Access Compliance Report Public Rights-of-Way (Curb Ramps)

Main Street: ARTISAN_ST		Cross Street: ARTISAN_ST		Location:	S
ADA ID: RPRK211020163734	Ramp Type: Type 4 - Parallel	Initial Pass/Fail: Fail	Overall Compliance: No	Severity Score:	2

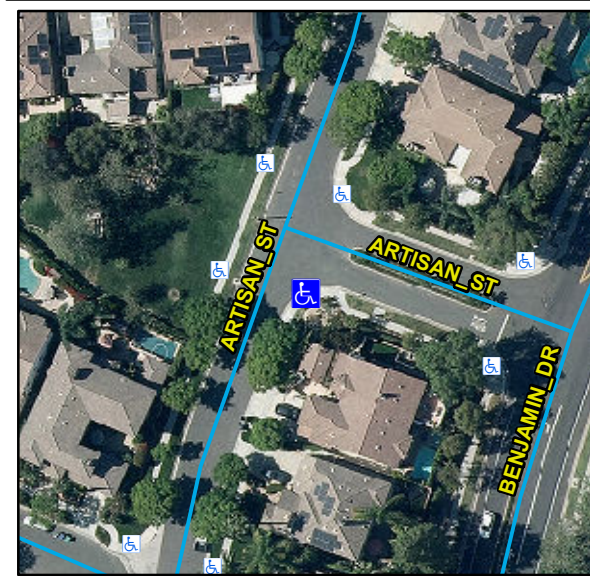
Compliance	Description	Data	Compliance	Description	Data
N/A	Ramp Length LT (in)	117	N/A	Ramp Length RT (in)	115
Yes	Ramp Width LT (in)	53	Yes	Ramp Width RT (in)	53
Yes	Ramp Run Slope LT (%)	7.6	Yes	Ramp Run Slope RT (%)	3.8
No	Ramp Cross Slope LT (%)	3.9	No	Ramp Cross Slope RT (%)	2.3
N/A	Landing Present	N/A	N/A	DWS Provided	N/A
N/A	Landing Length (in)	N/A	N/A	DWS Contrast	N/A
N/A	Landing Width (in)	N/A	N/A	DWS Length (in)	N/A
N/A	Landing Run Slope (%)	N/A	N/A	DWS Full Width	N/A
N/A	Landing Cross Slope (%)	N/A		DWS Offset Type	N/A
N/A	Landing Movement Obstructed?	N/A	N/A	DWS Offset Left (in)	N/A
	Landing Movement Type	N/A	N/A	DWS Offset Right (in)	N/A
N/A	Landing Shared	N/A			
N/A	Clear Space	Yes			
N/A	Clear Space To Crosswalk (in)	N/A			
N/A	Marked Crosswalk 1	No	N/A	Marked Crosswalk 2	No
	Crossing 1 Direction	NE		Crossing 2 Direction	NW
	Marked Crosswalk 1 Width (in)	N/A		Marked Crosswalk 2 Width (in)	N/A

N/A	Ramp Inside Crosswalk 1	N/A	N/A	Ramp Inside Crosswalk 2	N/A
	Crossing 1 Slope (%)	3.4		Crossing 2 Slope (%)	2.2
	Crossing 1 Cross Slope (%)	1.9		Crossing 2 Cross Slope (%)	1.8
N/A	Gutter Ponding	N/A	N/A	Curb Slope	6.2
Yes	Gutter Lip Height (in)	0		Road Run Slope (%)	0.9
N/A	Gutter Run Slope (%)	N/A		Road Cross Slope (%)	2.1
N/A	Gutter Cross Slope (%)	N/A	No	Perpendicular Joint Present	No
Yes	Overall Surface Condition	Acceptable			
	Cross Gutter Present?	No		Spandrel Present?	No
	Replace Cross Gutter?	N/A		Replace Spandrel?	N/A

Remove & Replace Curb Ramp With Two New Directional Ramps or Equivalent.

R204.3, R304.5.3, STD 1115
